## **Request for Class II Permissive Change**

Request for Class II Permissive Change FCC ID: T2Z-23444

## 23451-00001 User Interface Change Description

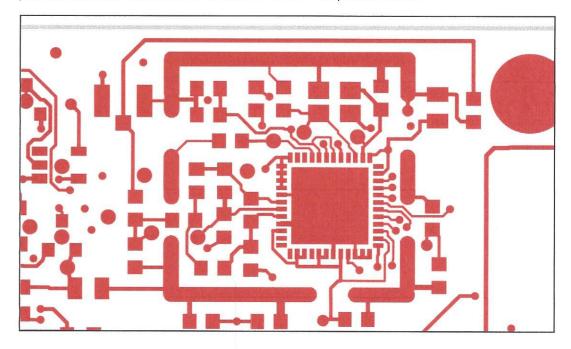
The PCB artwork is being adjusted on the revision ad assembly. This document shows the changes being made to the RF balun section by the removal of ICT (in circuit test) test points.

Graphic above shows the three test points being removed from the RF balun section. The graphic below shows the particular section of the corrected PCB artwork with the test points removed.
